To: T10 Technical Committee
 From: Rob Elliott, HP (elliott@hp.com)
 Date: 24 February 2005
 Subject: 05-086r0 SAS-1.1 Link layer timeout race conditions

Overview

Figure 1 — OPEN_REJECT racing BREAK

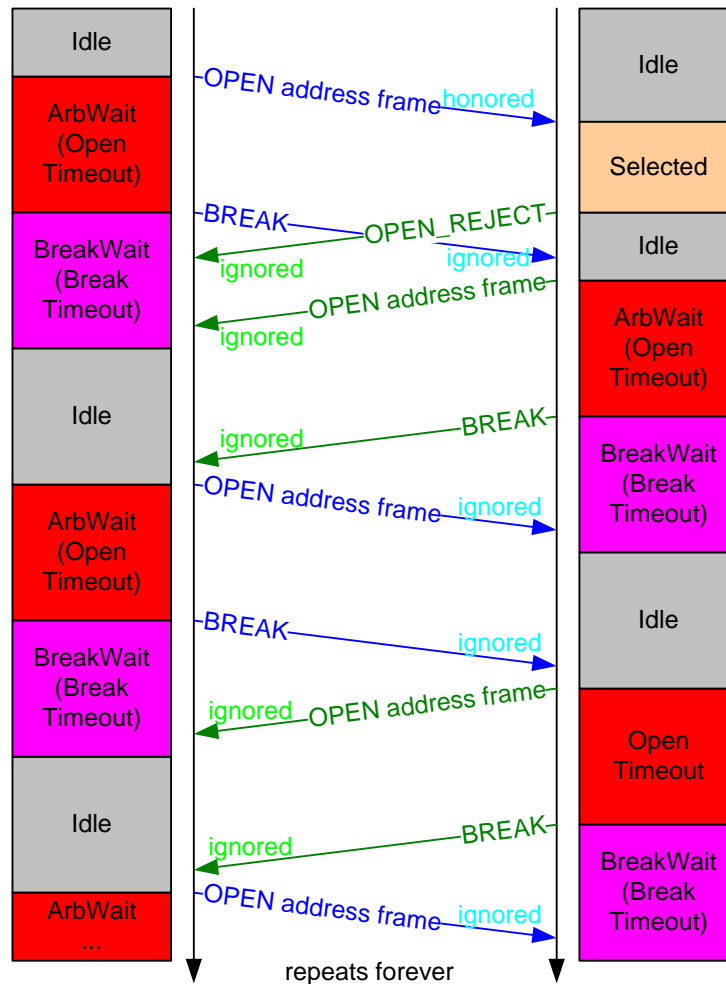
In the scenario, phy A sends an OPEN then sends BREAK (perhaps after an Open Timeout, or for any other reason) just as phy B sends OPEN_REJECT. When this happens, phy A ignores the OPEN_REJECT because its link layer state machine is sitting in the SL_CC or XL Break_Wait state (which is just looking for an incoming BREAK). Phy B ignores the BREAK because it is in the idle state. If phy B then sends an OPEN, it is ignored by phy A which is still in the Break_Wait state. Phy A experiences a BREAK Timeout and returns to idle, but then Phy B experiences an Open Timeout and sends BREAK; phy A ignores the BREAK. The two phys ping-pong OPENS and BREAKs forever.

The suggested solution was to make the Break_Wait state proceed to the Idle state upon receiving OPEN_REJECT (in addition to receiving BREAK).

Figure 2 — CLOSE racing BREAK

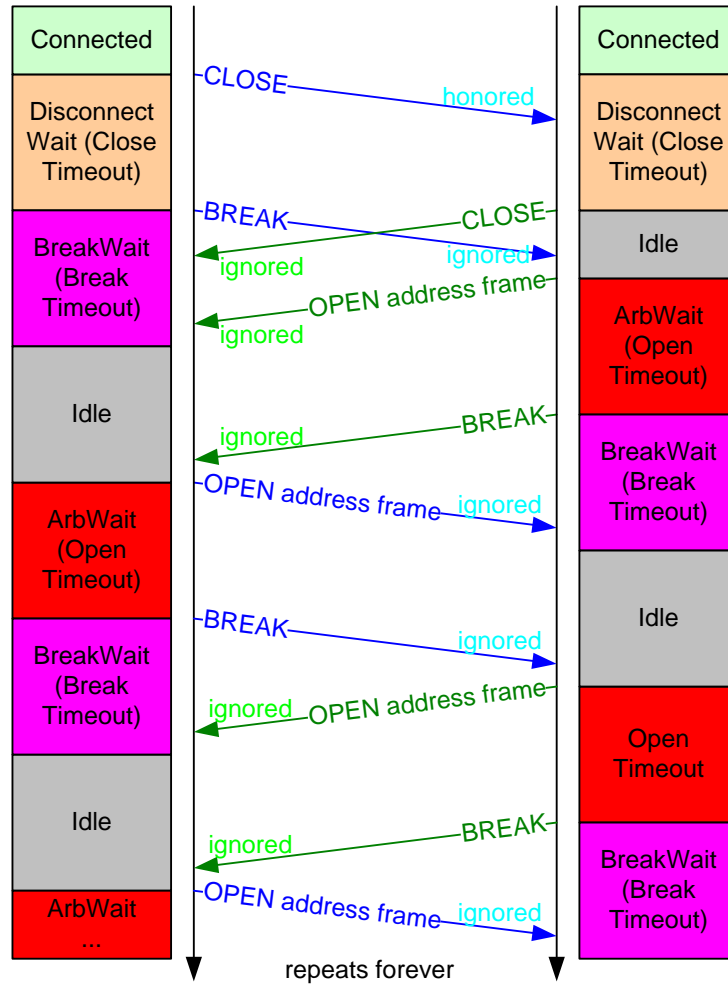
However, Mark Evans (Maxtor) noted there are other reasons the state machine might be in Break_Wait and experience similar problems. When a closing a connection, if the incoming CLOSE arrives just after the Close Timeout timer expires triggering an outgoing BREAK, the phys enter the same loop.

The SL_CC and XL state machines have numerous reasons to enter the Break_Wait state including CLOSE Timeouts (see table below), all of which may cause this problem.

Minor related problem: With the change made by 05-040, an OPEN_REJECT sends the state machine back to Idle even if Break_Wait was entered because of a missing CLOSE. The transition needs to be conditioned upon “and this state was entered from SL_CC1:ArbSel”.

A combination of time limits and additional transitions from Break_Wait are proposed. The time limits just standardize the behavior of current implementations and ensure that, if applications don't arbitrary cause

BREAKs, no race conditions will occur. The additional transitions ensure that applications can cause BREAKs without causing a problem.

Figure 14 — SSP (link layer for SSP phys) state machines (part 1 - frame transmission)

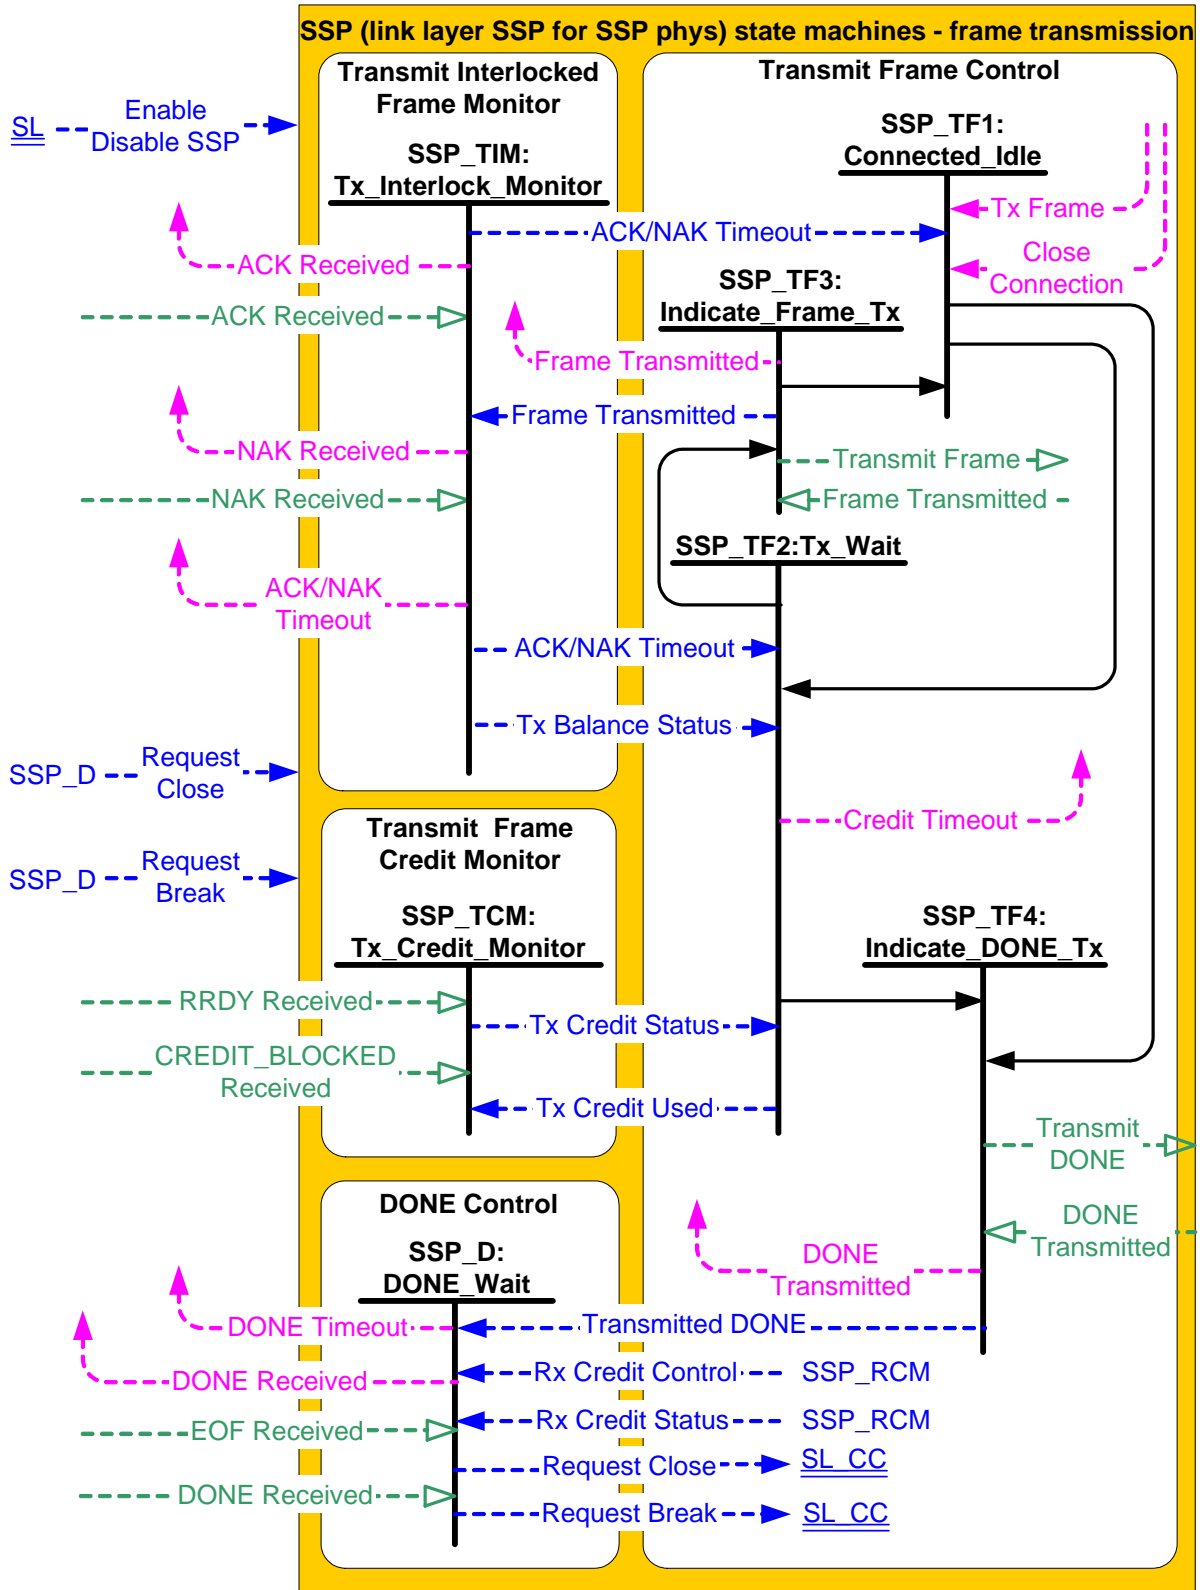
Editor's Note 1: change TF3 and TF4 state names in figure
